LUSCOMBE AIRPLANE CORPORATION
West Trenton, New Jersey

ENGINEERING BULLETIN NO. 18

RECOMMENDED REPAIR AND ALTERATION FOR FRAYING RUDDER CABLES

Aircraft Affected: All Luscombe Model 8 Series aircraft up to and including
Serial No. 1894

INSTALLATION DETAILS

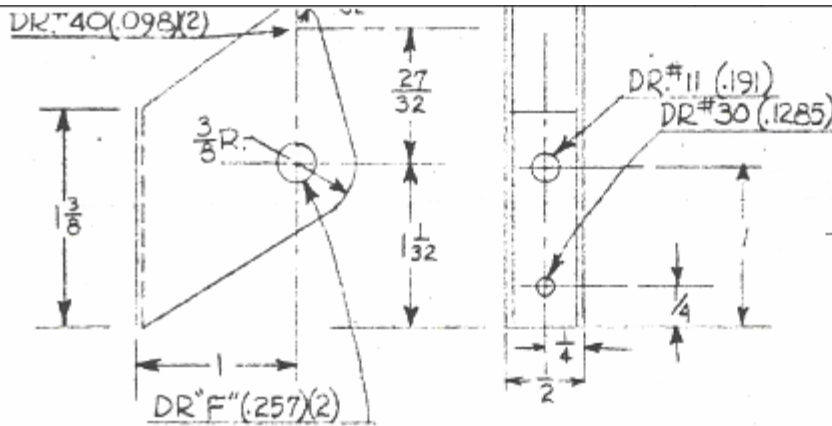
The fraying of rudder cables at bulkhead #7 has led to the substitution of pulleys (LAC Drawing #28099) for the former fairleads (LAC Drawing #18058), and to our recommendation that you make the same change on any and all subject aircraft in your possession as soon as possible.

The Civil Aeronautics Administration will require the above change be made before the next annual certification of these aircraft. The required change is outlined and illustrated on the accompanying page.

1. Replace the worn rudder cables with new ones, Luscombe Airplane Corporation parts #48501-2 and #48501-3.
2. Locate pulley bracket as per sketch, making sure the rudder cables do not rub against the skin slots, and drill #7 bulkhead to match.
3. Bolt bracket in place.
4. Safety cables over pulleys as per sketch and adjust.
